JOINT REGIONAL PLANNING PANEL (Sydney East Region)

JRPP NUMBER:	2012 SYE 105
DA NUMBER:	LDA2012/0417
LOCAL GOVERNMENT AREA:	City of Ryde
PROPOSED DEVELOPMENT:	Demolition of an existing building and the construction and use of a 7 storey mixed use development with ground floor retail, 62 residential units (12 studios, 37 x 1 bed and 13 x 2 bed) and parking for 82 vehicles within 3 basement levels. The application includes development on both private land and public land (road reserve), the latter being owned by the City of Ryde Council.
STREET ADDRESS:	1-3 Wharf Road Gladesville, plus areas of existing public roads in Meriton Street and Wharf Road. The total “site” area is 1,330m², comprised of 1-3 Wharf Road (625m² approx.) and road reserve (705m²).
APPLICANT:	Windesea Build Pty Ltd
NUMBER OF SUBMISSIONS:	52 objections and 132 letters of support. The vast majority of these letters of objection and support were in a pro-forma format.
RECOMMENDATION	Submission of amended plans for further consideration by the Panel.

Assessment Report and Recommendation

Figure 15: Approximate location of Lot A relative to scale of the building.

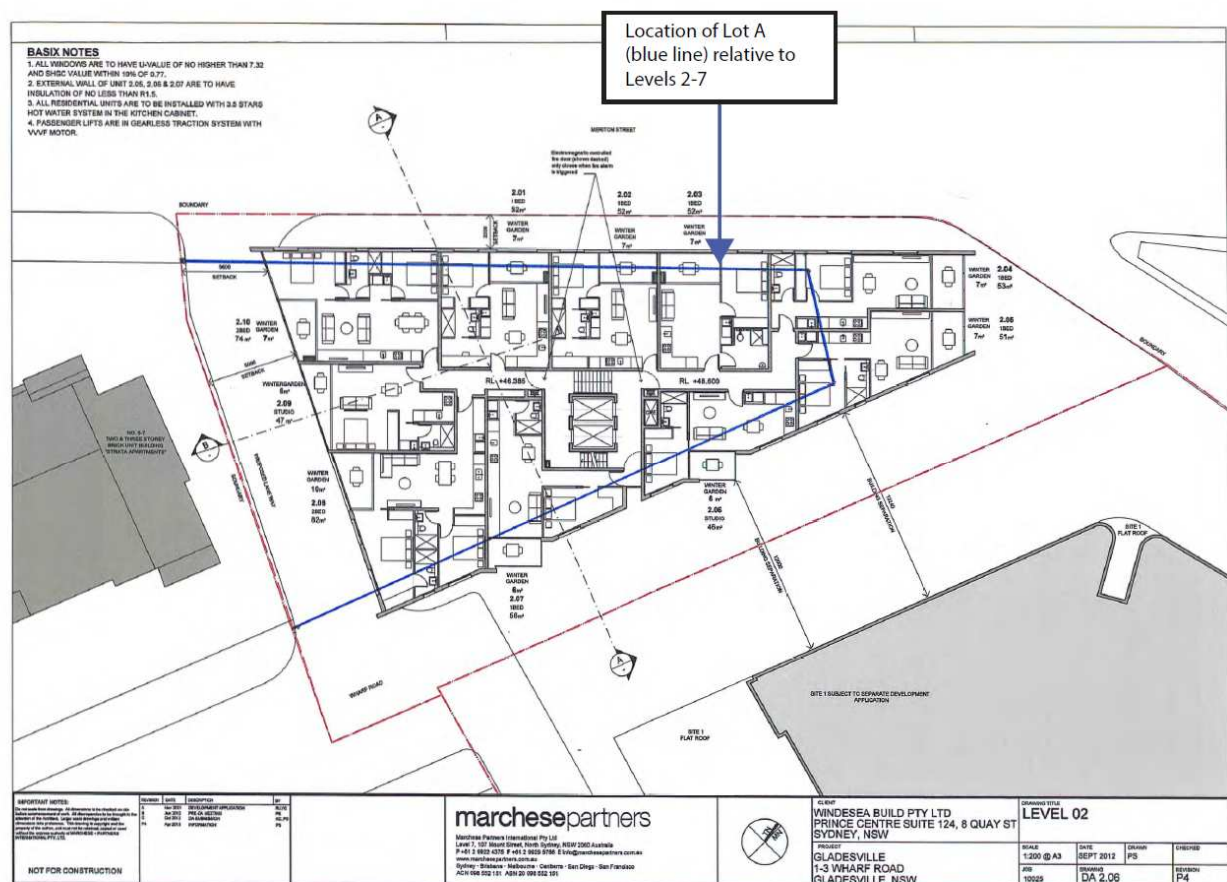
The assessment of the acceptability of the variation is however complicated by the building taking up a greater footprint than envisaged in the planning controls, thereby being greater in width, bulk and scale.

The extent of the additional width and scale of the built form, relative to the existing Lot A is shown in Figure 15 below.

Figure 16: RDCP 2010 Key Sites built form plan

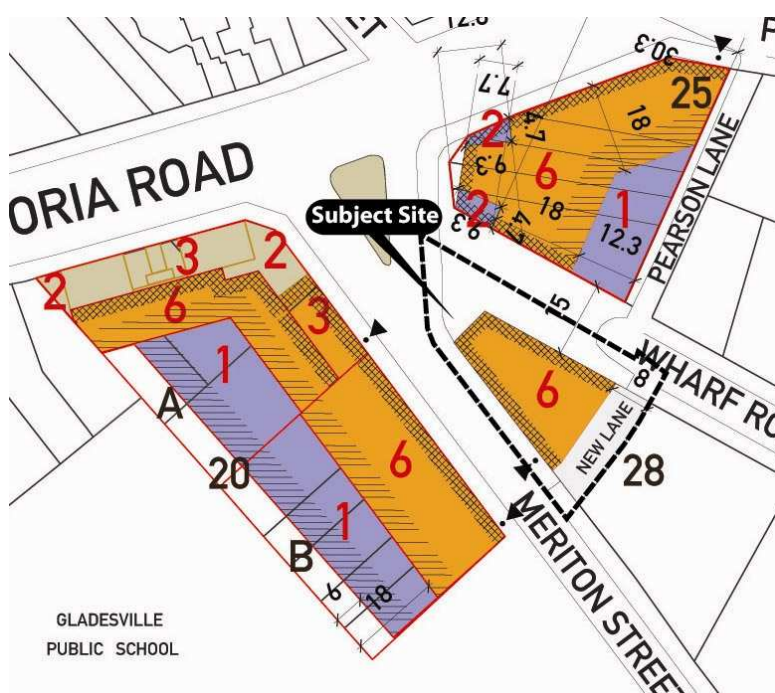
As noted in the report the DA is inconsistent with the key sites diagram for the subject site. The Key Sites diagram is shown below in Figure 16.

The DA does not comply with the Key Sites diagram contained in RDCP 2010.

Figure 18: ground floor of the development relative to Lot A, shown in blue

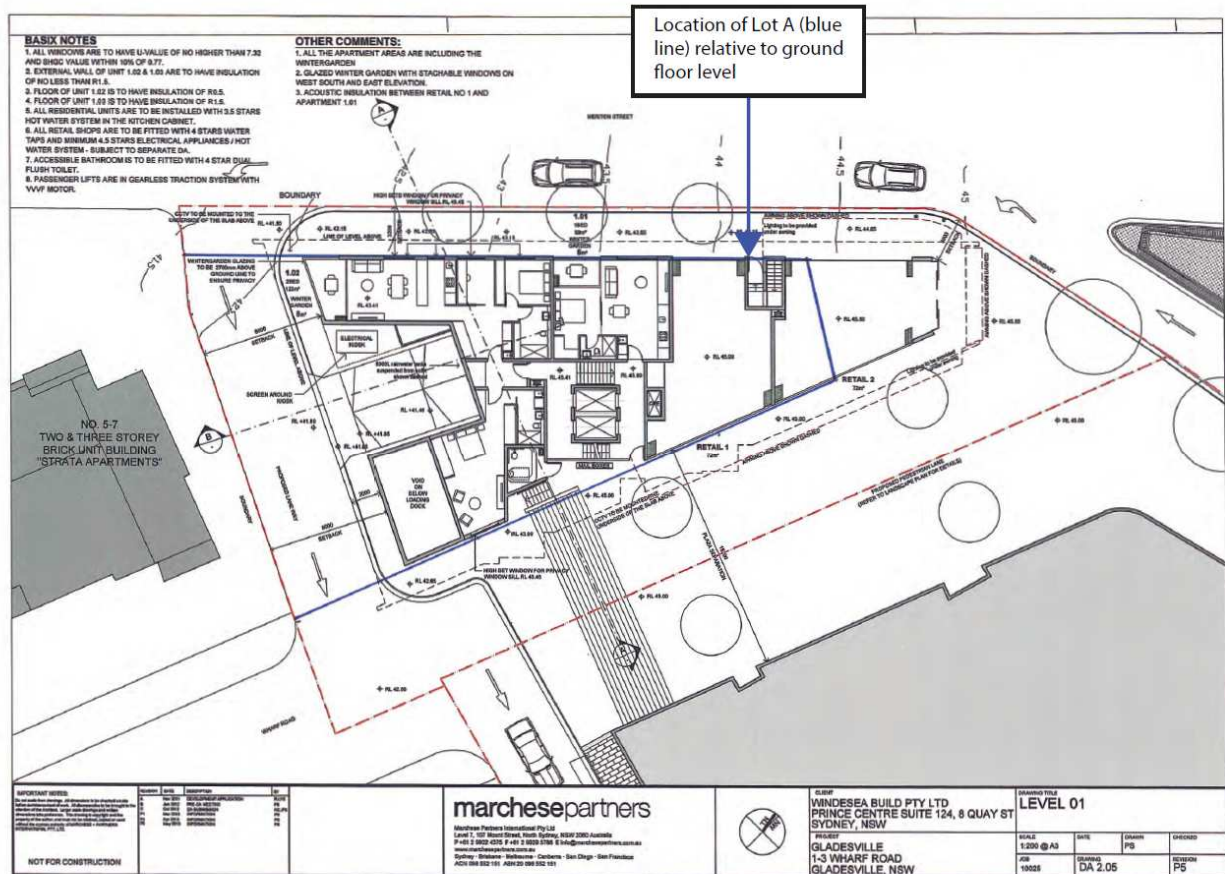
The departure from the Key Sites diagram and related controls is the threshold issue associated with the DA. Due to the Council and the applicant agreeing, separately to the DA process, to respectively sell and purchase additional land and establish a larger development site, the opportunity exists for the applicant to pursue a greater scale and density of development, based on the enlarged development site.
